FORD E40D "UPDATE HANDBOOK"

INTRODUCTION FORD E4OD "UPDATE HANDBOOK"

**FORD E40D
VALVE BODY, SPACER PLATE, SPACER PLATE GASKETS,
CHECKBALL LOCATIONS, AND CASE CHANGES,
FOR THE 1996 MODEL YEAR**

Figure 55

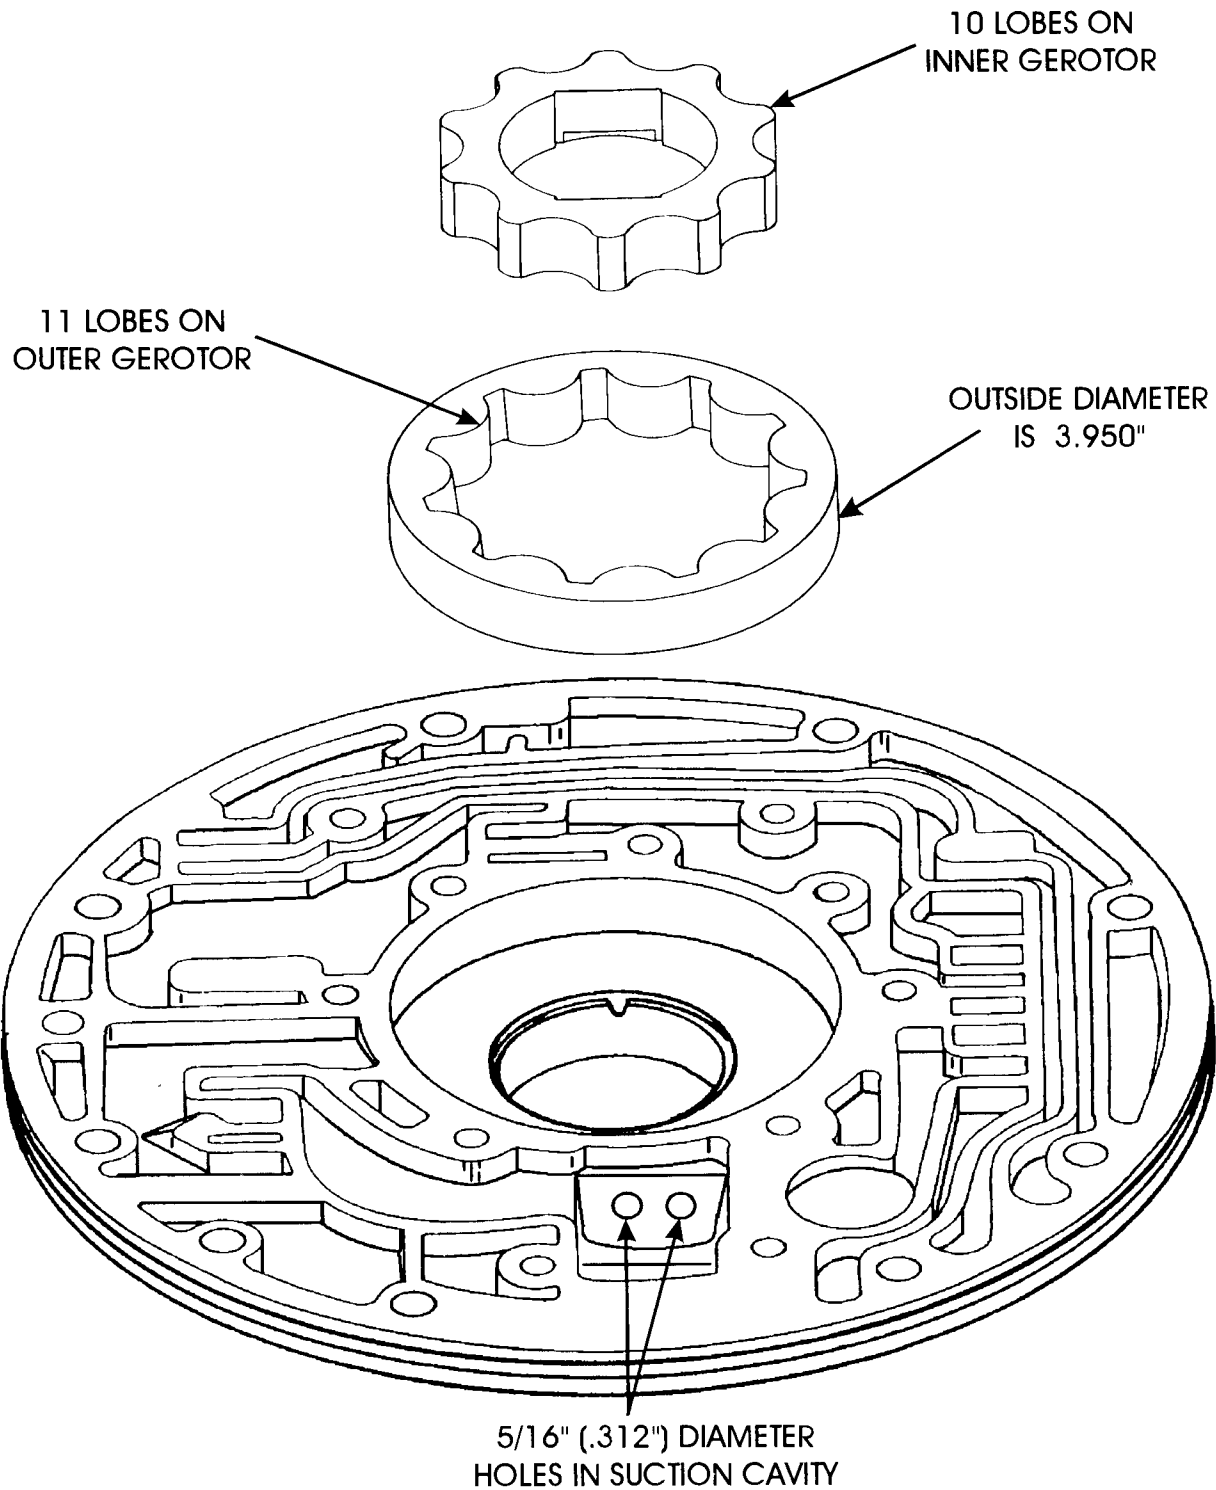
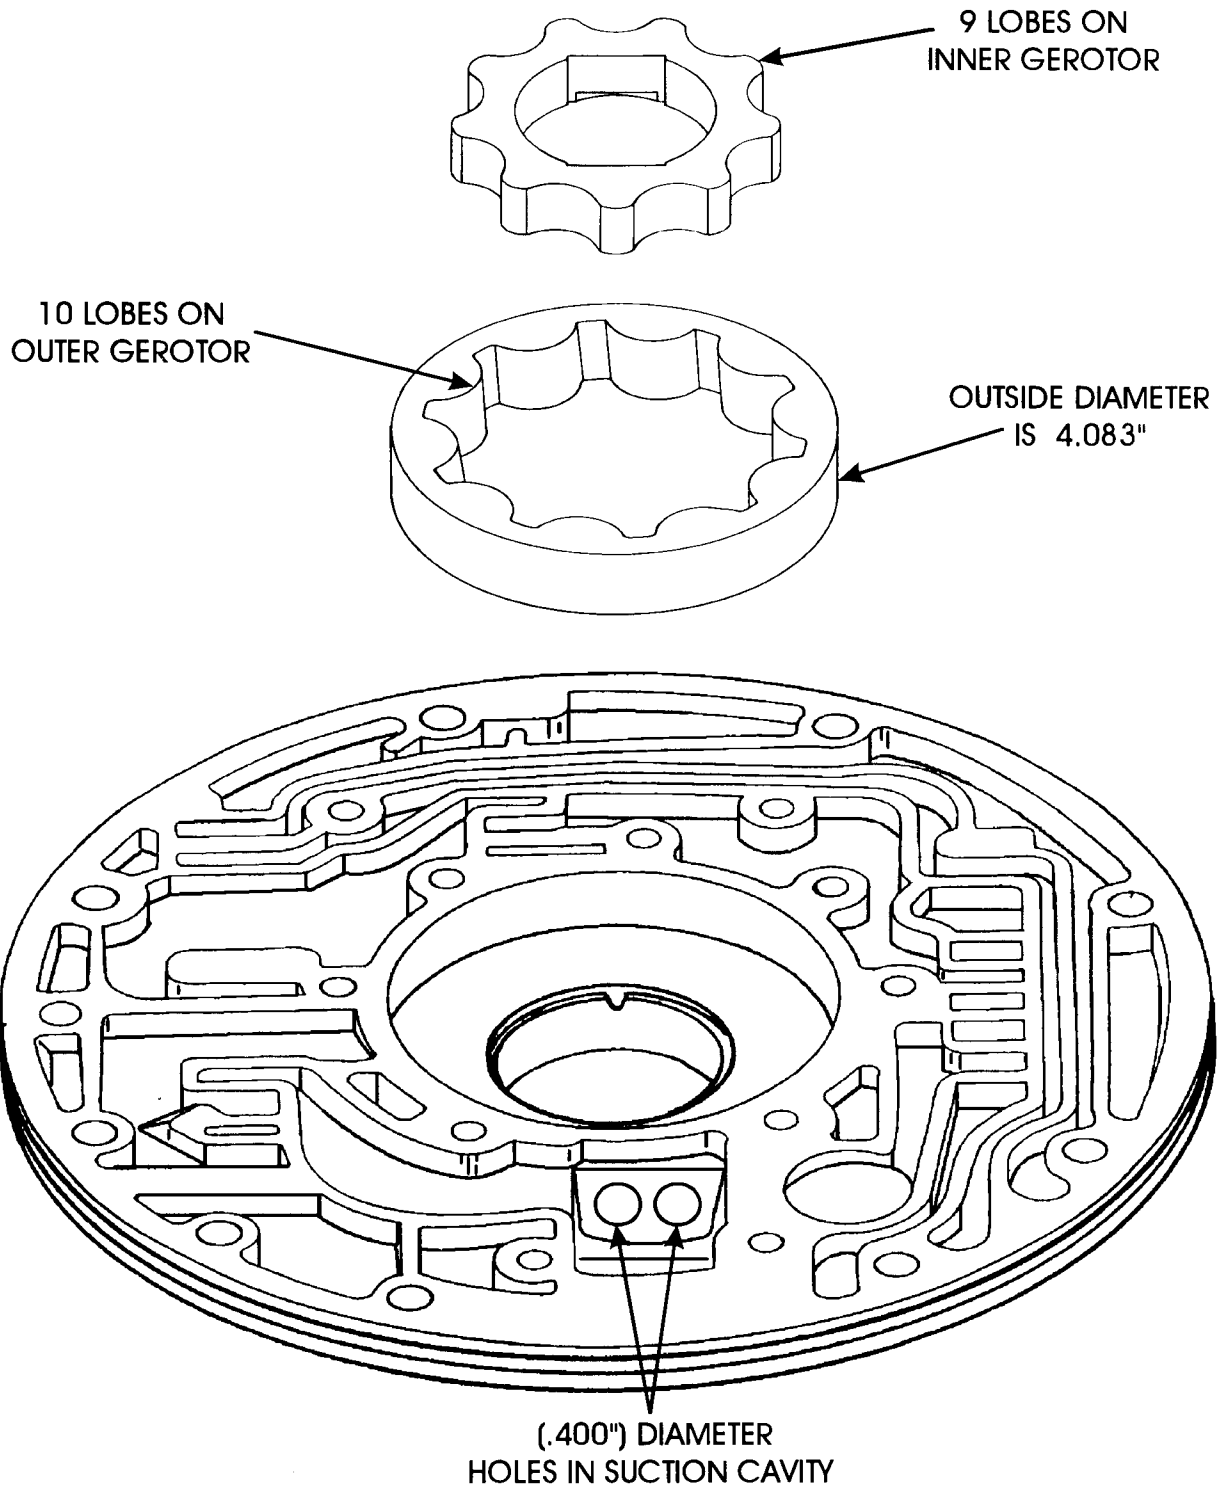
- (3) **INNER GEROTOR** - The lobes on the Inner Gerotor changed from the previous 10 lobes to 9 lobes on the new design, to accommodate the changes on the outer gerotor. Refer to Figures 55 and 56. The changes on both the inner and outer gerotor increased the cavity between the gerotors for increased pump volume, as shown in Figure 57.

Figure 57

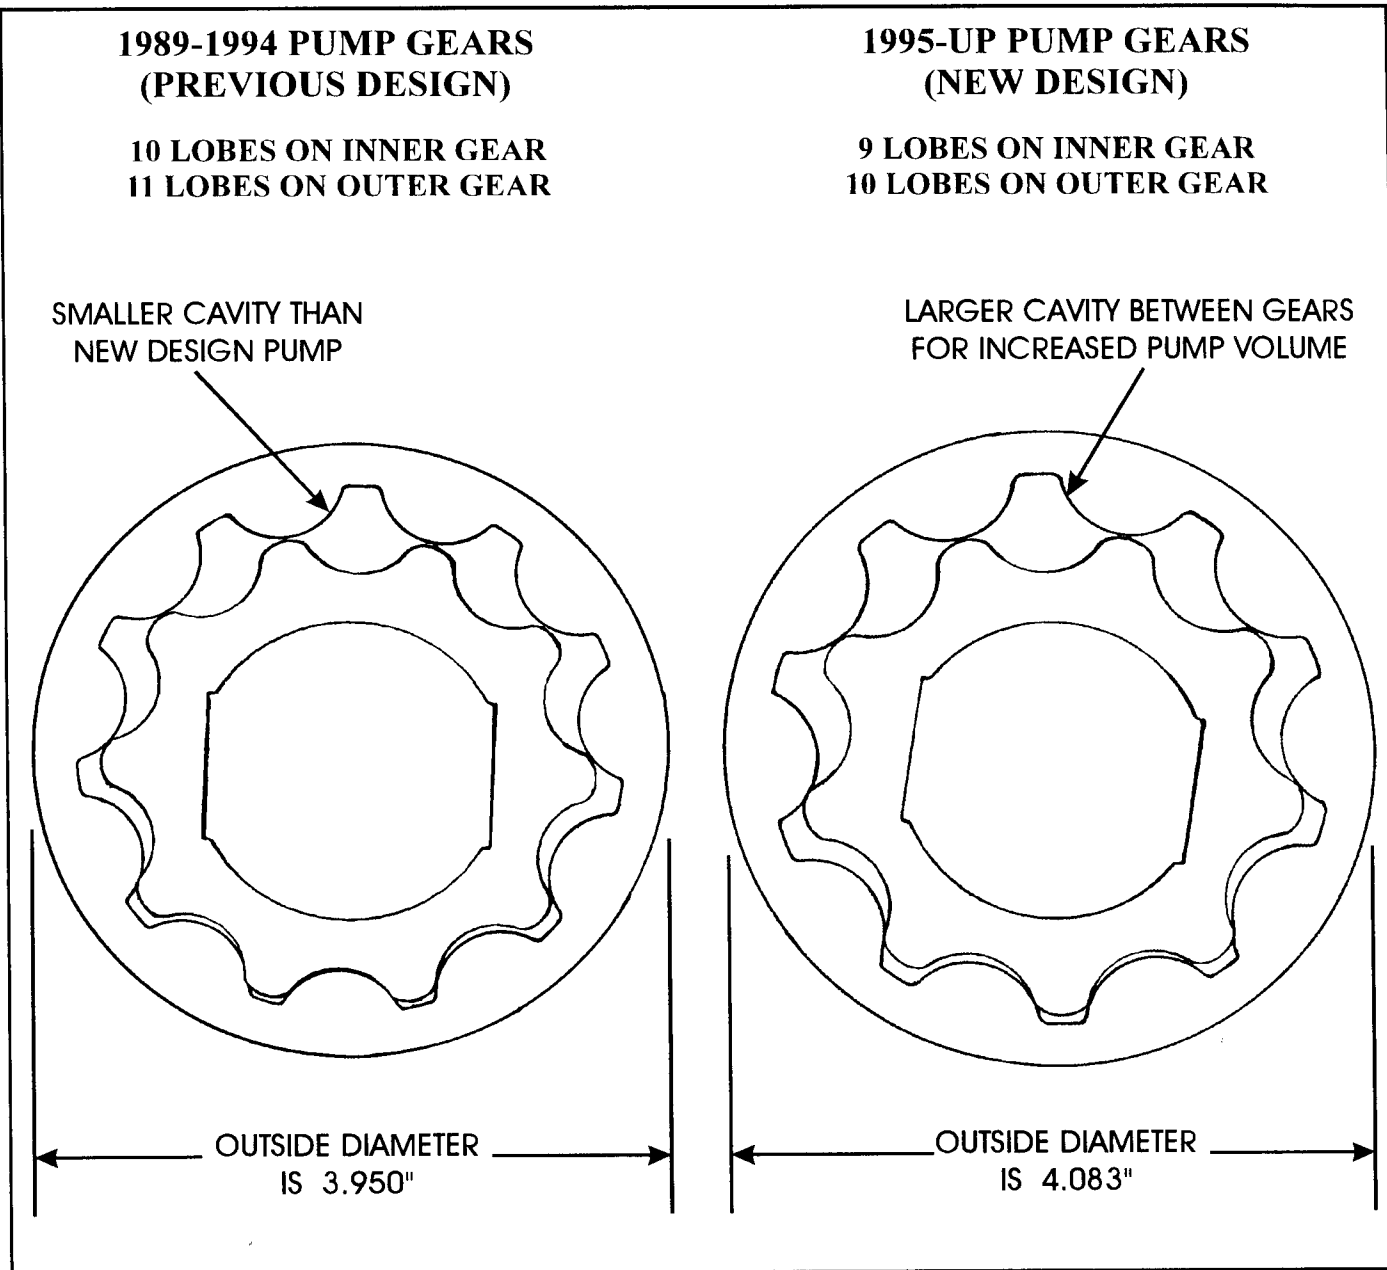
- (2) **OUTER GEROTOR** - The lobes on the Outer Gerotor changed from the previous 11 lobes to 10 lobes on the new design, to accommodate the changes on the inner gerotor. The diameter of the Outer Gerotor also changed from 3.950" to 4.083". Refer to Figures 55 and 56. The changes on both the inner and outer gerotor increased the cavity between the gerotors for increased pump volume, as shown in Figure 57.

Figure 61

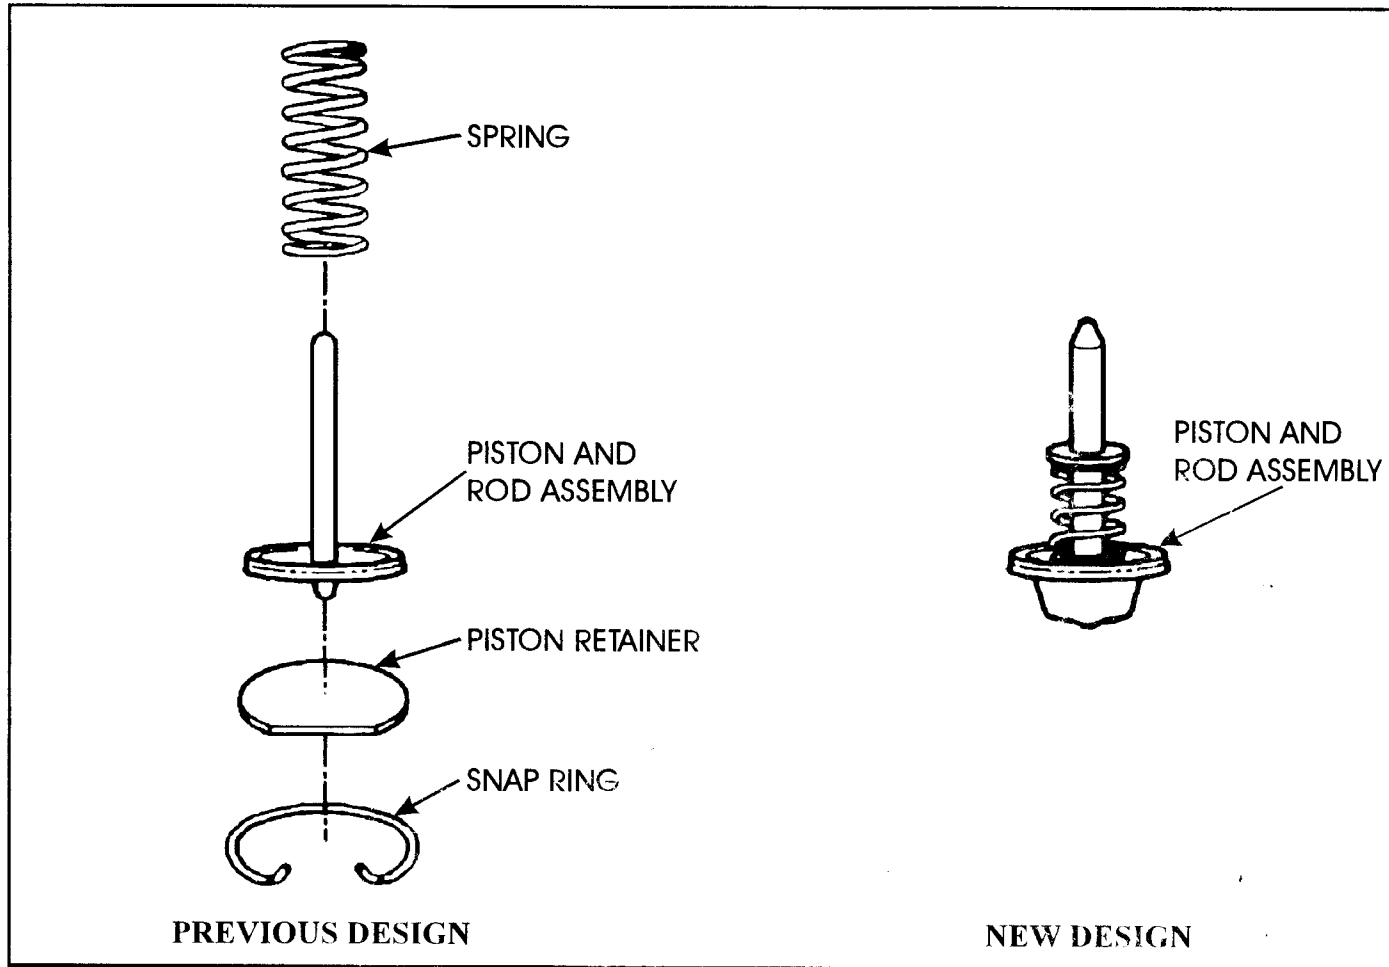
CHANGE: Beginning on August 8, 1995, all 1996 model E4OD transmissions were produced with a new design Intermediate Band Apply Servo Assembly (See Figure 61).

- (1) INTERMEDIATE SERVO PISTON - Total change in design, as shown in Figure 61.
- (2) SERVO PISTON RETAINER - Eliminated, as shown in Figure 61.
- (3) RETAINING SNAP RING - Eliminated, as shown in Figure 61.
- (4) TRANSMISSION CASE - Snap ring groove in the case piston bore was eliminated, as it was no longer need (See Figure 62).

Figure 63

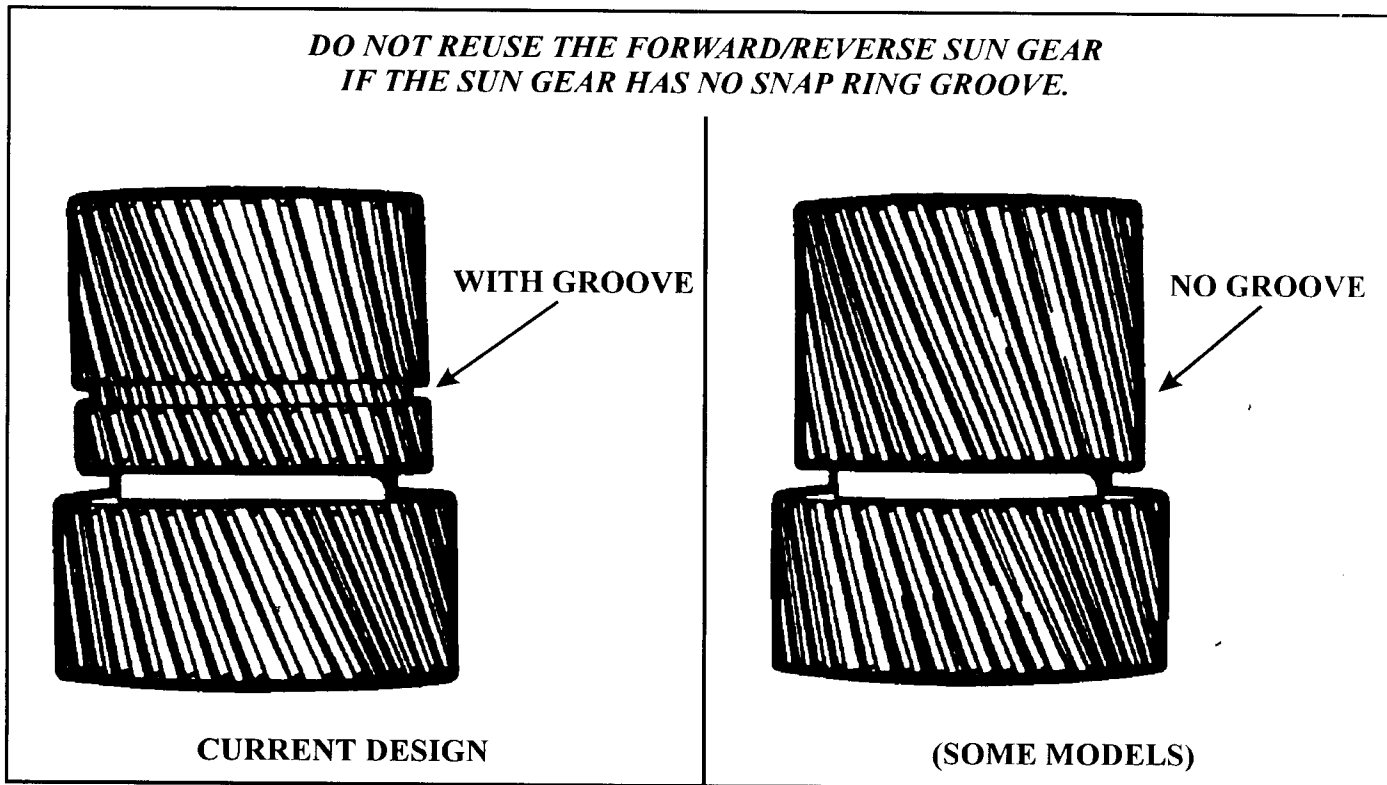
Some models of the E4OD transmission have been built with a Forward/Reverse Sun Gear that does not require a retaining snap ring, and has no groove for a snap ring, as shown in Figure 63. These transmissions are identified as model PRA-FA 12, serial number 00157935 thru 00158019. If internal transmission repair is required for these units, replace the Forward/Reverse Sun Gear with the current service sun gear with the snap ring groove, and the snap ring (See Figure 63).

***DO NOT REUSE THE FORWARD/REVERSE SUN GEAR
IF THE SUN GEAR HAS NO SNAP RING GROOVE.***

Figure 77

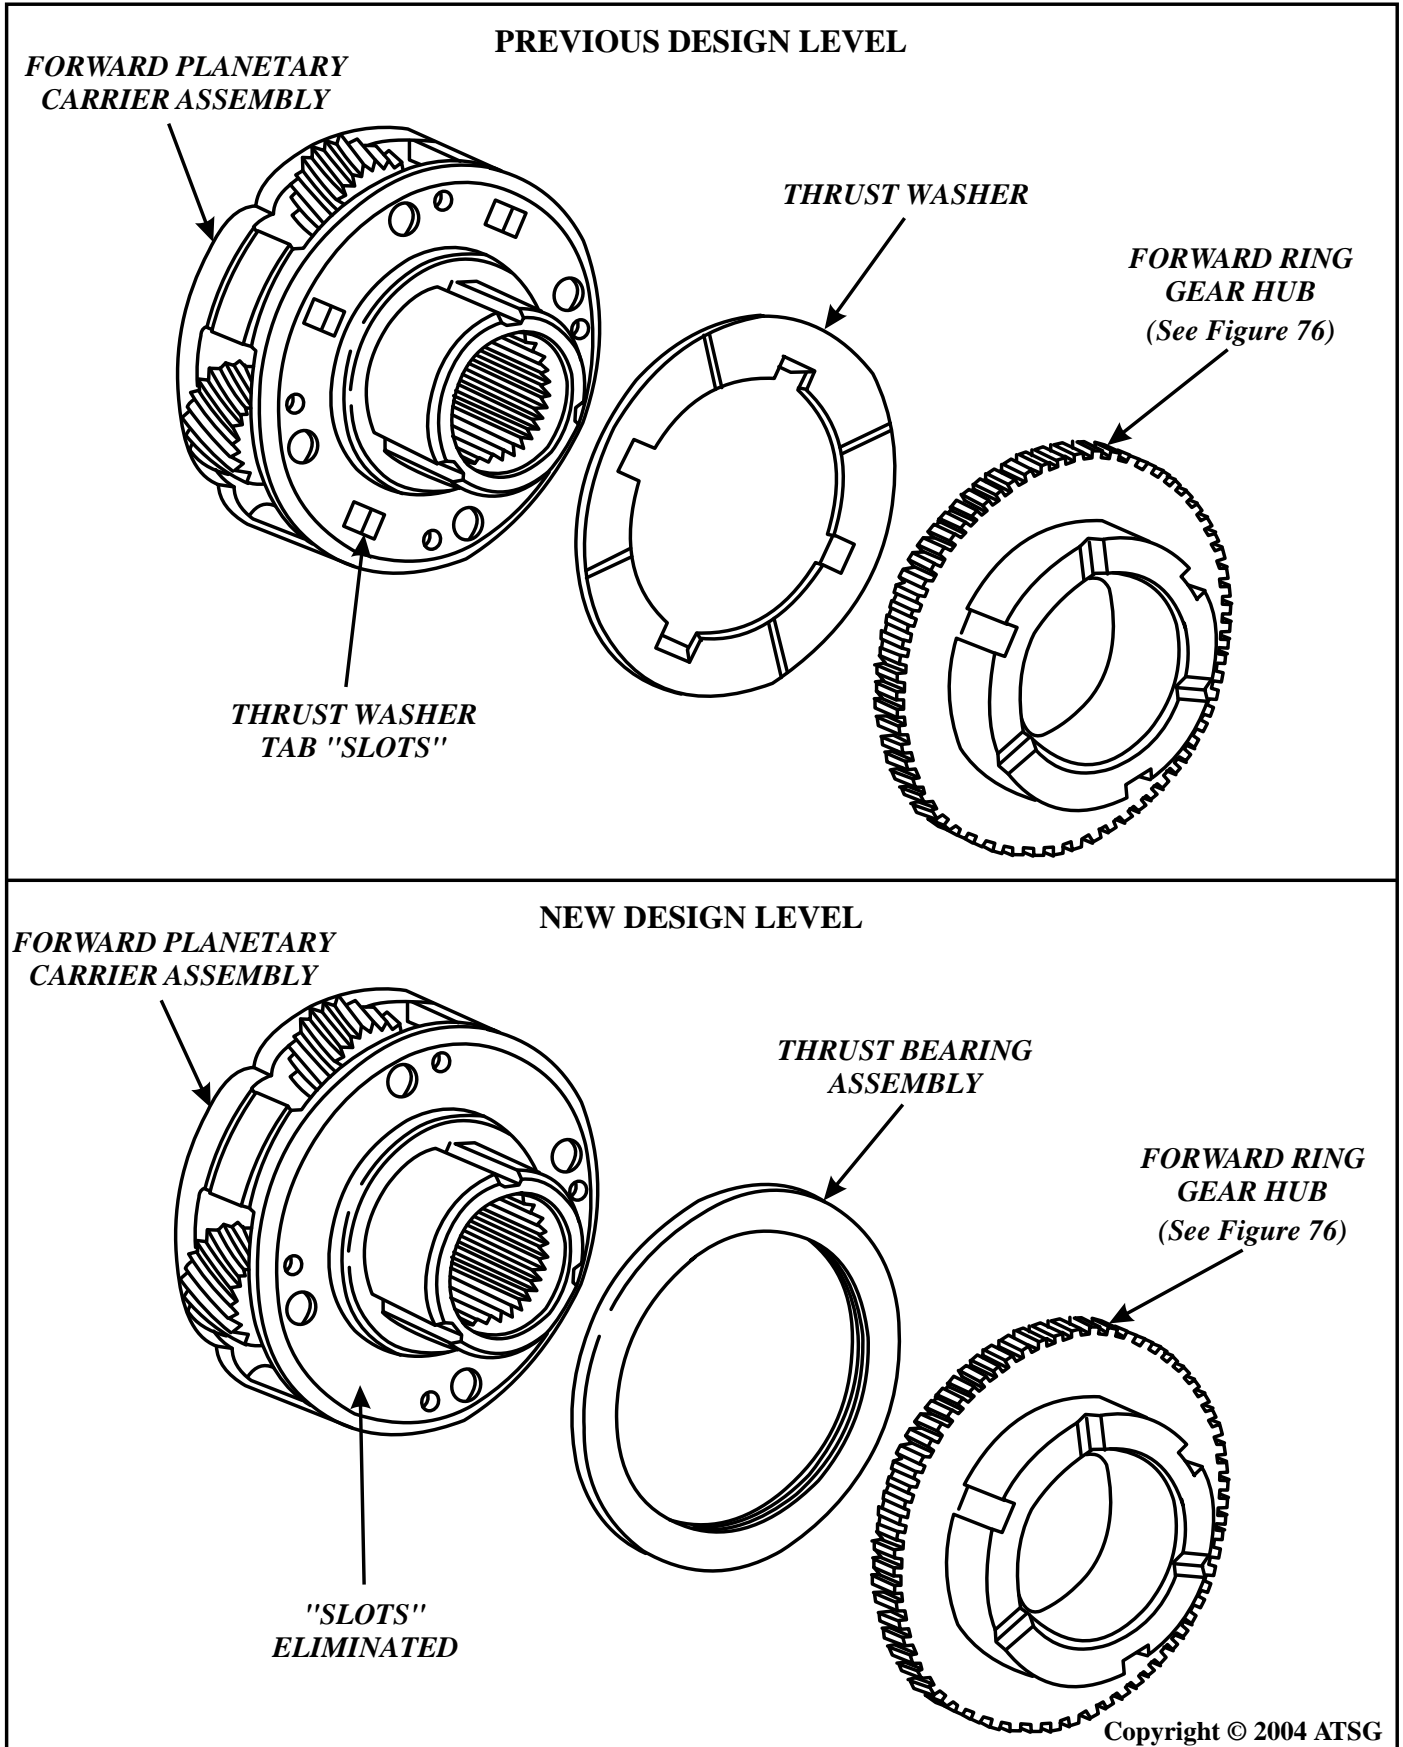
CHANGE: Beginning at the start of production for the 1997 model year, Ford Motor Company introduced a new design Forward Clutch Ring Gear Hub, to accommodate a new thrust bearing, that replaces the thrust washer on the forward planetary carrier, and a new design Forward Planetary Carrier that eliminates the thrust washer tab slots (See Figures 76 and 77).

- (2) New design Thrust Bearing must be used only with the new design Ring Gear Hub. It cannot be used on any previous models (See Figure 76).
- (3) There is also a new part number for the Forward Planetary Carrier, with no dimensional changes, and will retro-fit back on all previous models, but, *some* of the new part number carriers will not be cut to accept the four tang thrust washer. In that case you will have to install the new thrust bearing, which means you will also have to replace the ring gear hub with the new design level (See Figure 77).
